Our Ref: 25007.M01.001
EDQ Ref: DEV-2026-WGB-4573

**RE: REQUEST FOR CHANGE TO EXISTING DEVELOPMENT APPROVAL FOR MATERIAL CHANGE OF USE
ON LAND LOCATED AT 24 WILTON STREET, WOOLLOONGABBA. EDQ REF: DEV-2026-WGB-4573.**

This planning assessment accompanies a change application pursuant to Section 99 of the Economic Development Act 2012, in relation to subject site at 24 Wilton Street, Woolloongabba and described as Lot 4 on RP12250.

Figure 7 - Revised ground level

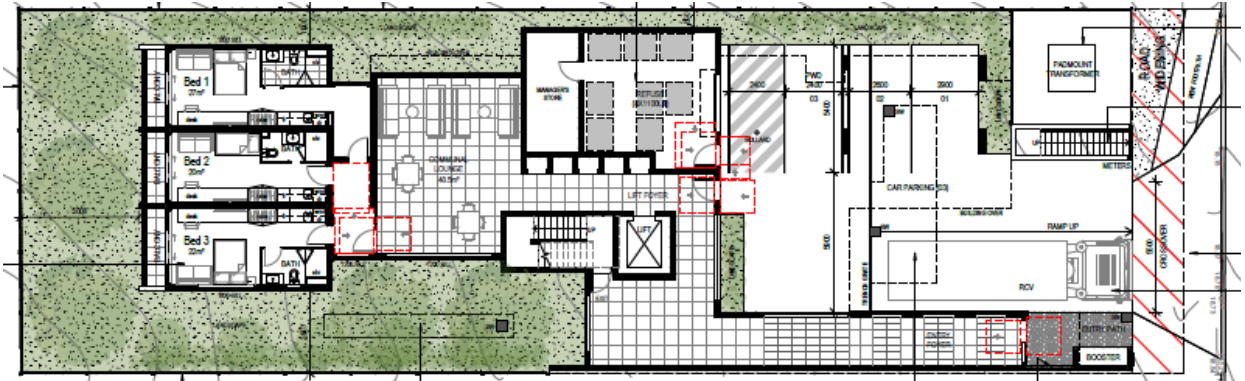
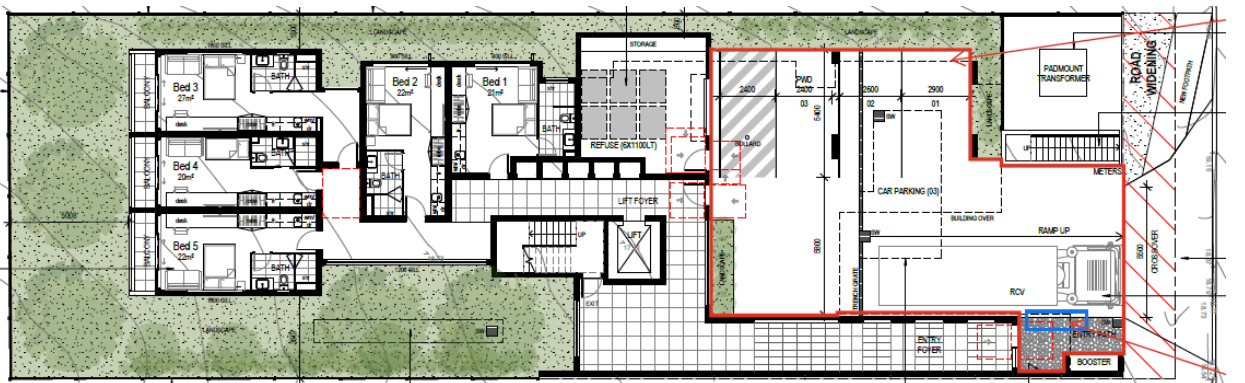
- **Ground level plan** – minor changes to the ground level layout include:
 - The deletion of 2 rooming units to provide additional communal room area.
 - Increase refuse storage area.
 - No changes are proposed to access and parking layout.

Figure 9 - Revised level 1

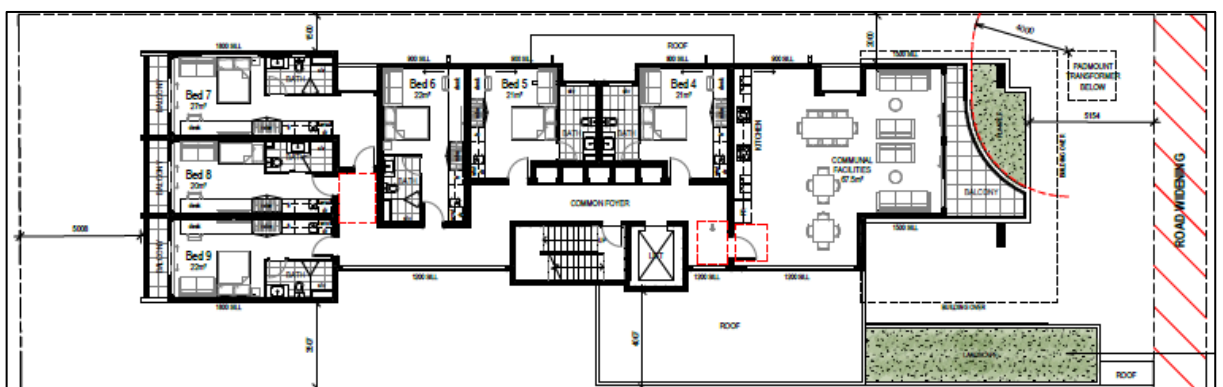
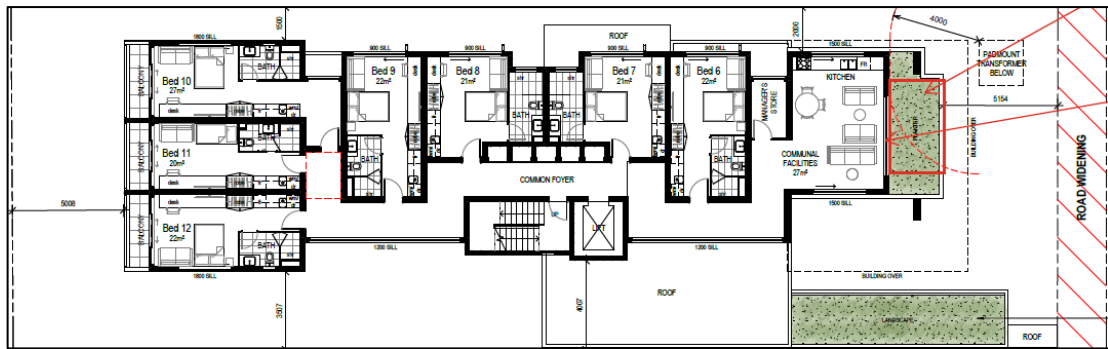
- **Level 1 plan** – minor changes to the ground level layout include:
 - Removal of 1 unit to provide an increased communal area.
 - Add partial front balcony to communal area.

Figure 11 – Revised Typical level 2-5 layout

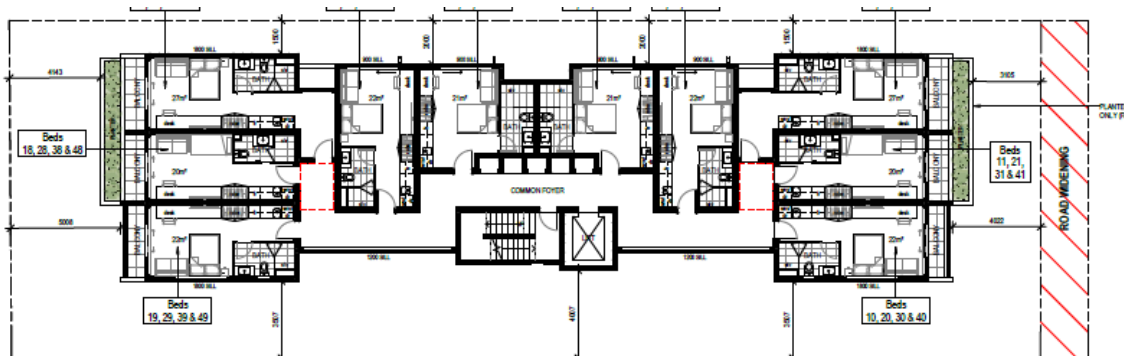
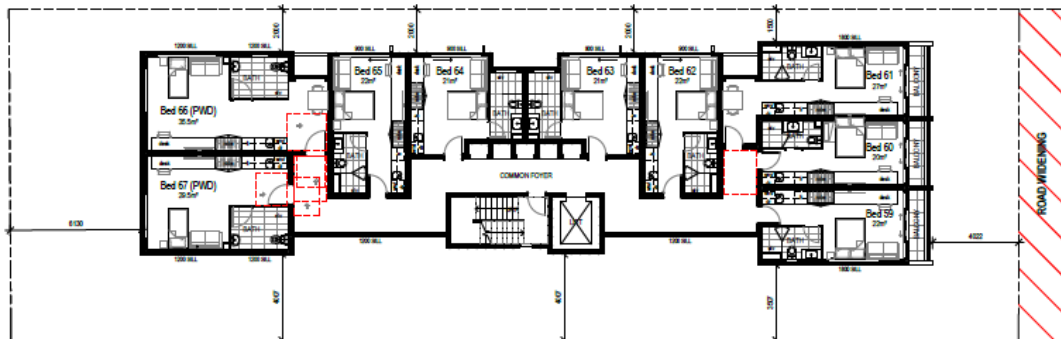
- **Levels 2-5 plan** – Layout is same as the previous typical 10-room layout for levels 2-3.
